LITCHFIELD PARK SERVICE COMPANY

RE: LPSCO Palm Valley Water Reclamation Facility
Docket No. SW-01428A-06-0444
Our File No. 8600-06-20-01

Report from McBride Engineering Solutions

Re: LPSCO Palm Valley WRF
Question from the ACC Regarding Odor Control Measures
(ACC Docket No. SW-01428A-05-0022; SW-01428A-06-0444)

Figure B-1. Influent Odor Control Measures Schematic

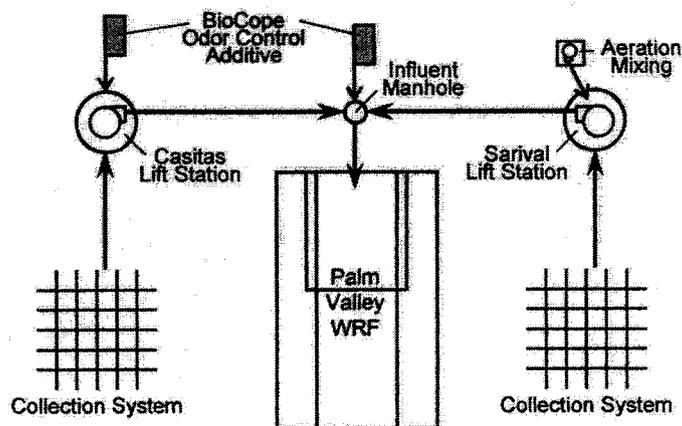
To reduce the amount of odors coming into the facility from the collection system, a temporary system to add an odor control compound was installed at the Casitas Lift Station and at the Palm Valley WRF influent manhole. The odor control additive compound being utilized is BioCope, a chemical that has already been successfully used to mitigate odors in the collection system of Algonquin's Black Mountain Sewer Company in Cave Creek.

It is expected that the installation of this system in May 2007, along with an aeration mixing system installed at the Sarival Lift station, will significantly reduce the odors carried to the WRF with the raw wastewater influent. In addition, BioCope is designed to break down the fats, oils, and grease (FOGs) that are significant contributors to odor generation in the plant processes. Figure B-1 is a schematic showing how these measures have been implemented.

Figure E-1. Odor Control Schematic for Ion-Exchange System Pilot

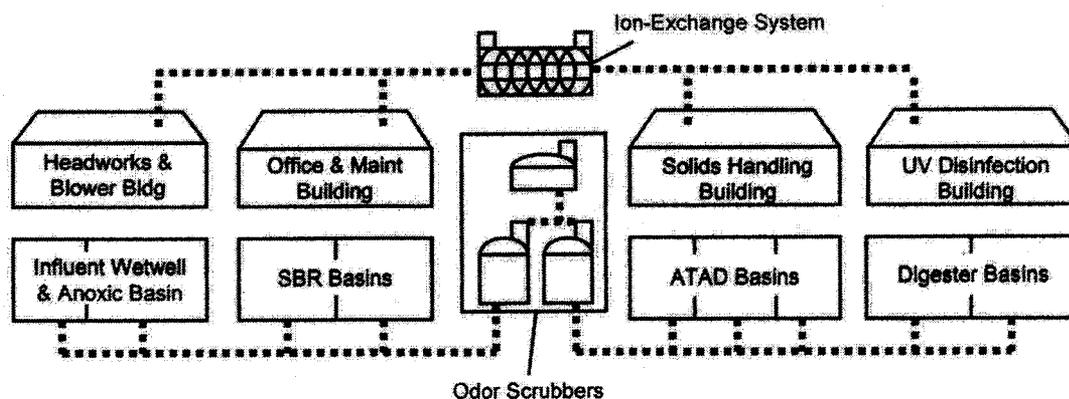
In the near-term, Algonquin has authorized a full-scale pilot test by IonStein, Inc. to install and test an ion-exchange odor-control system at the facility. The plan is to significantly reduce the load on the existing scrubbers by dedicating them exclusively to the below-grade process tanks (influent wet well, anoxic basin, SBR basins, ATAD basins, and digester basins), and then using the ion exchange facility to treat the air in the above-grade buildings (headworks and blower building, office and maintenance building, solids handling building, and UV disinfection building). It is anticipated that this system will be functional by July 2007. Figure E-1 is a schematic depicting how the system would be configured during the full-scale pilot.
